MONTGOMERY COUNTY PLANNING DEPARTMENT
THE MARYLAND-NATIONAL CAPITAL PARK AND PLANNING COMMISSION

MEMORANDUM

PROJECT: Century Boulevard, From 300 Feet South of Father Hurley Boulevard to
Future Dorsey Mill Road
Subdivision Road Participation Project SRP-71
CIP Project No. 508000
NRI/FSD #4-93023

REVIEW TYPE: Mandatory Referral No. 08803-DPW&T-1

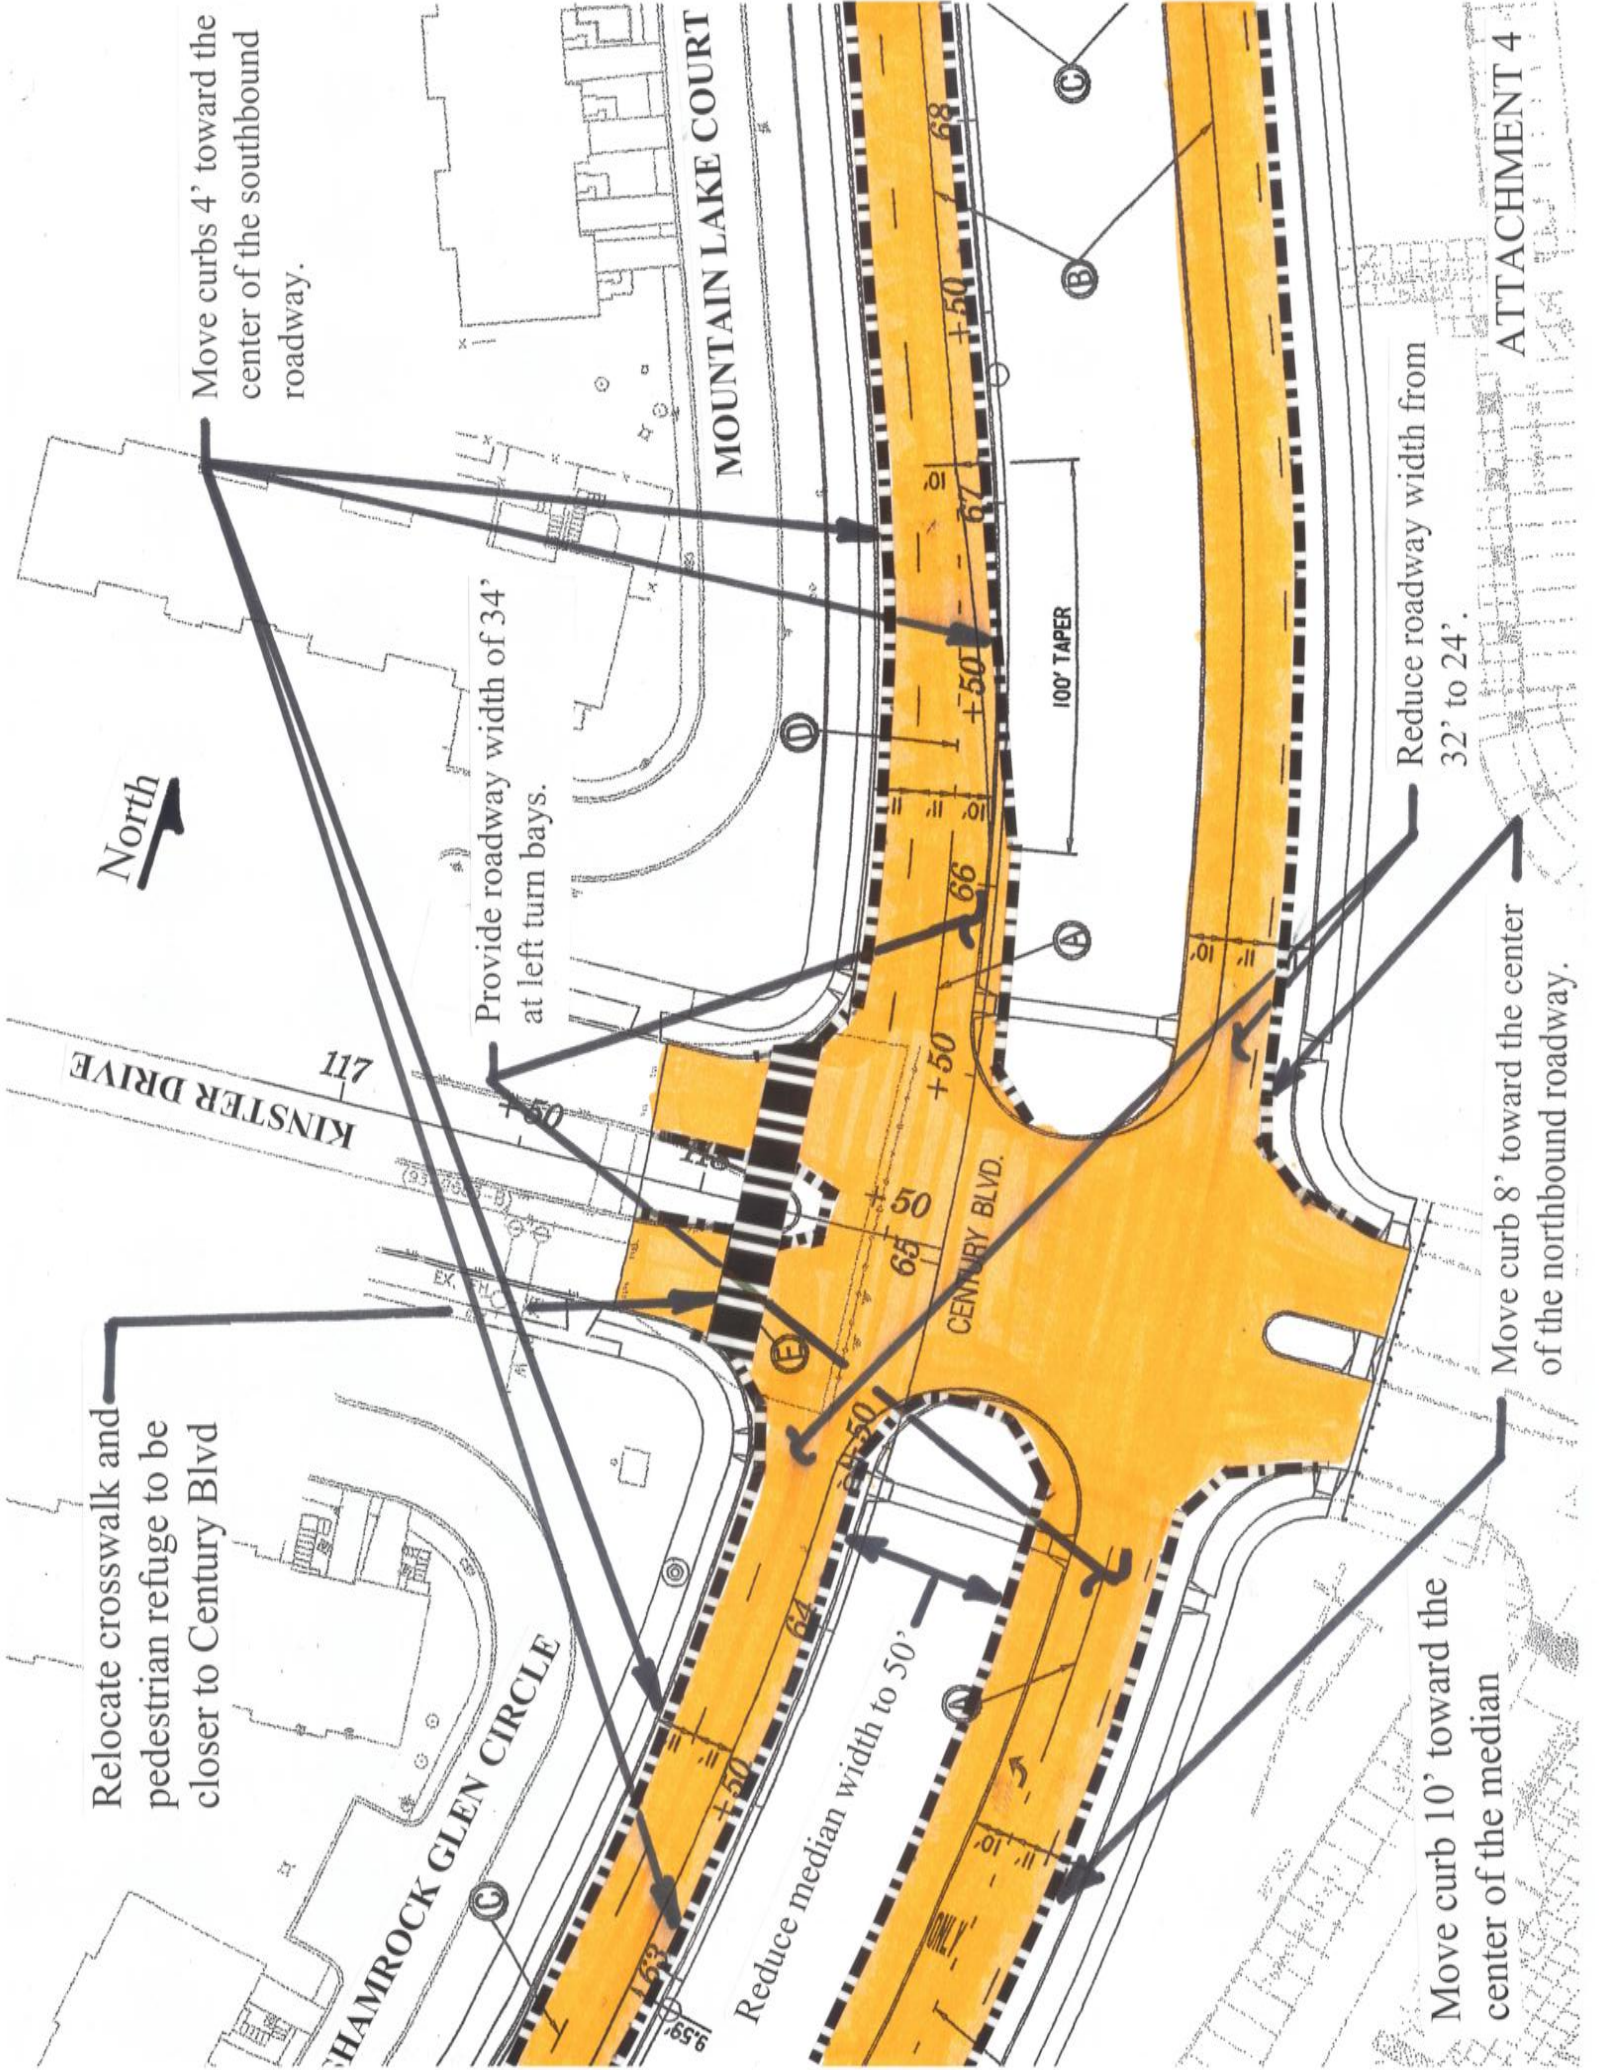
Relocate crosswalk and pedestrian refuge to be closer to Century Blvd

Move curbs 4' toward the center of the southbound roadway.

Provide roadway width of 34' at left turn bays.

Reduce median width to 50'

Move curb 10' toward the center of the median

Reduce roadway width from 32' to 24'.

Move curb 8' toward the center of the northbound roadway.

Proposed Century Boulevard
would go under existing Father
Hurley Boulevard Bridge

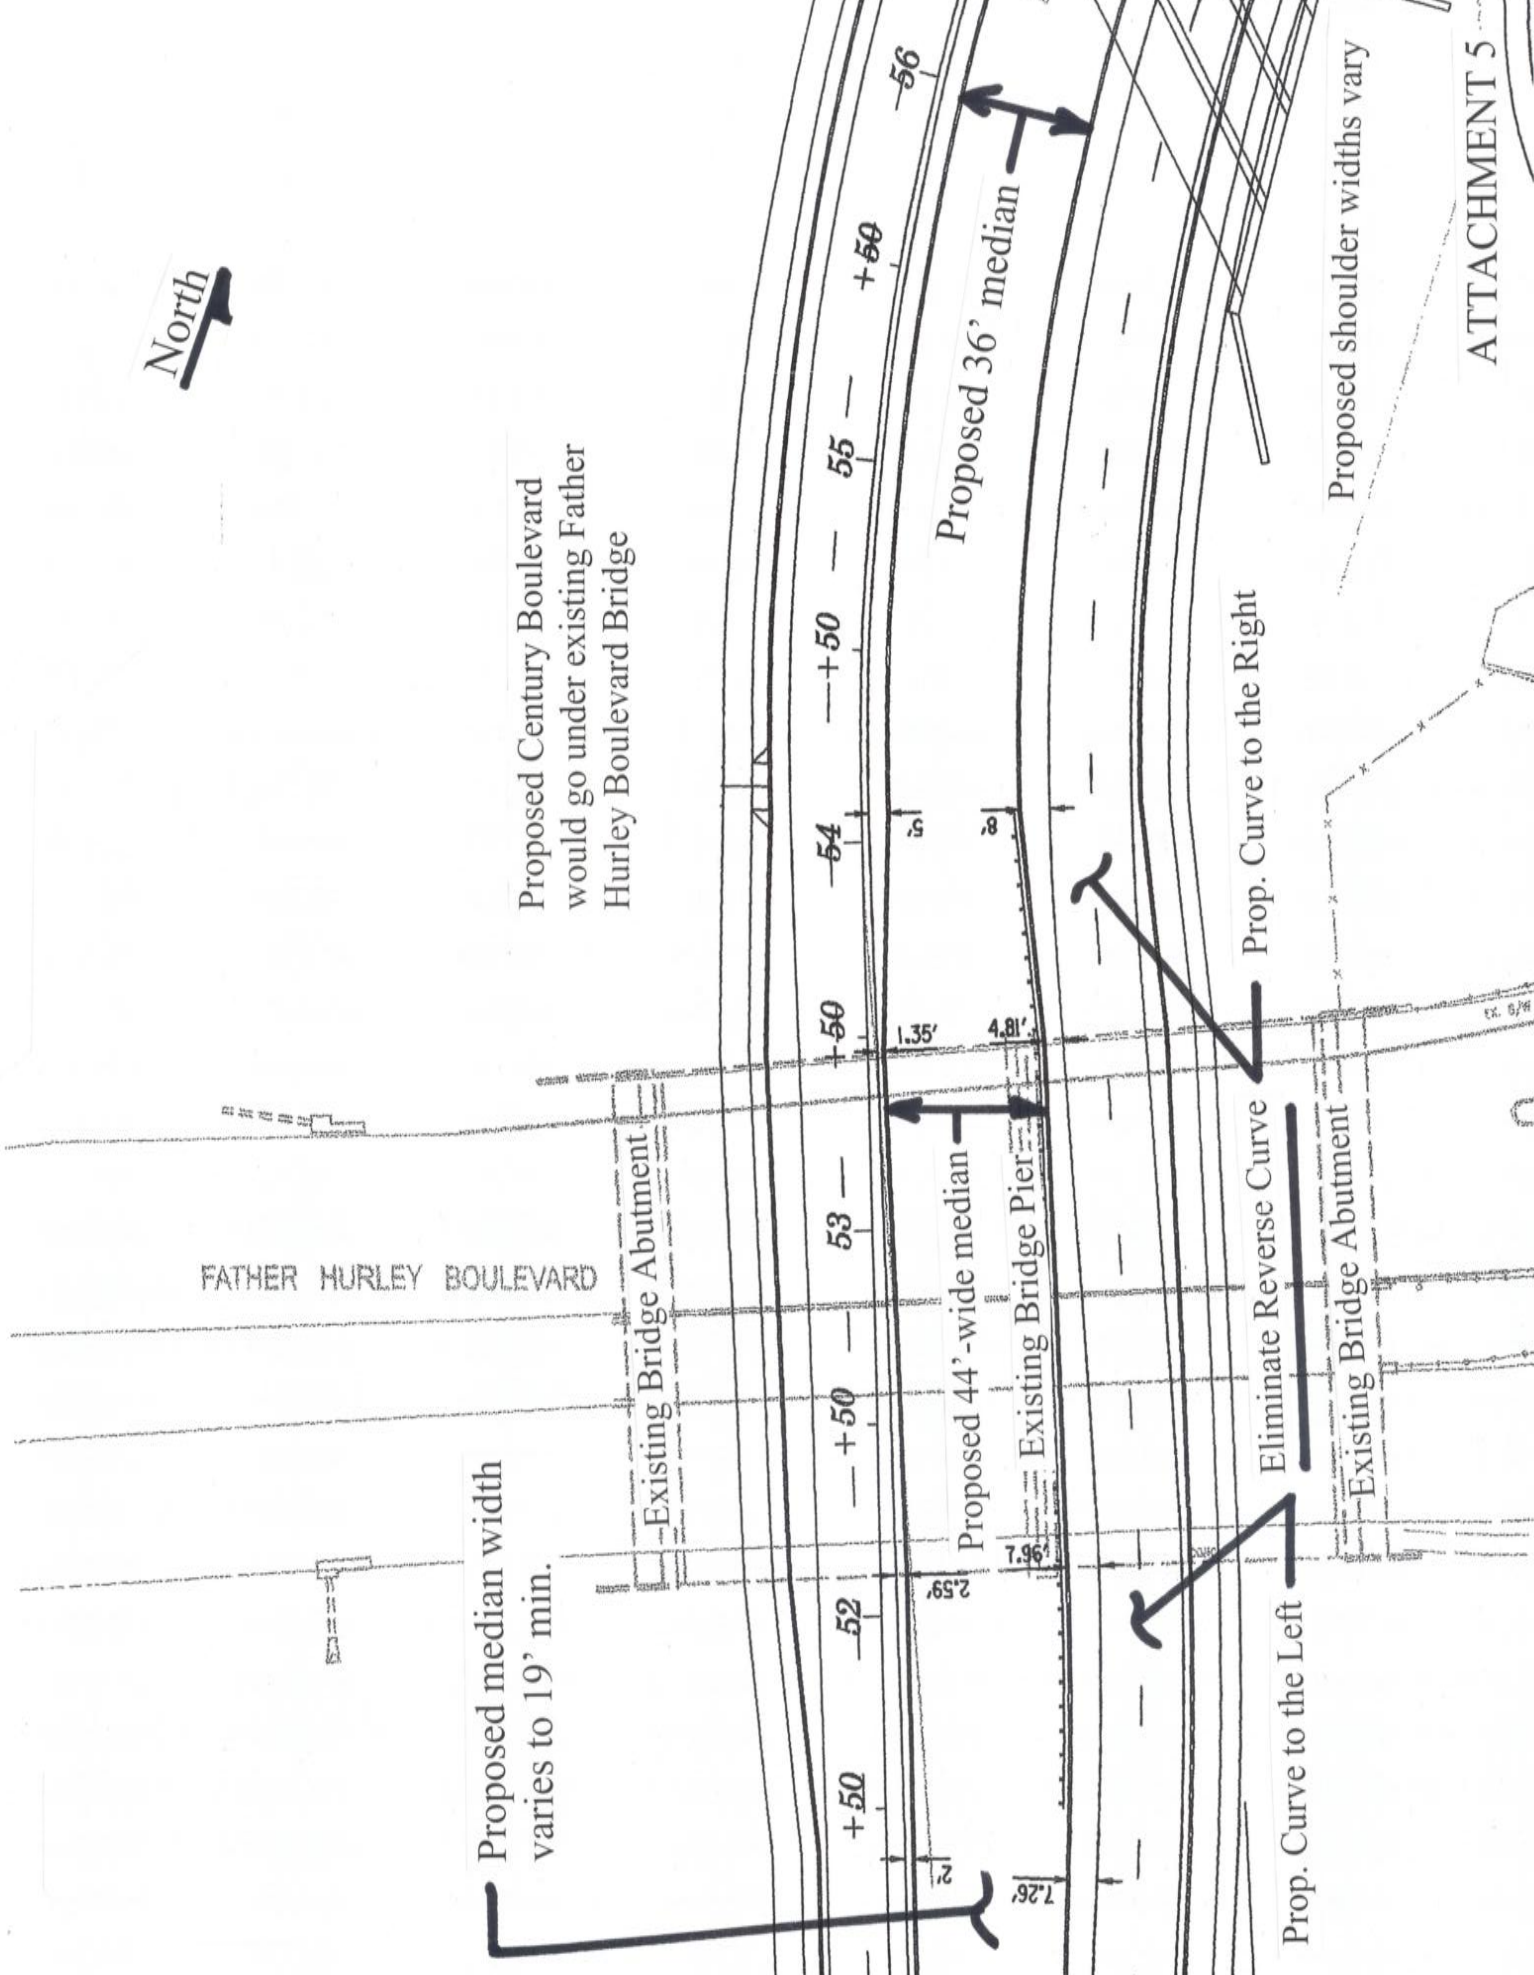
Proposed median width
varies to 19' min.

Proposed 44' -wide median

Eliminate Reverse Curve

Proposed 36' median

Proposed shoulder widths vary

Staff recommends that additional fixtures be provided to adequately light the southbound roadway and sidewalk under the bridge

Staff recommends that a landscape panel with street trees be provided in this segment.

Provide dual handicap ramps at corners and provide pedestrian refuges in medians.

Reduce roadway width from 26' to 24'.
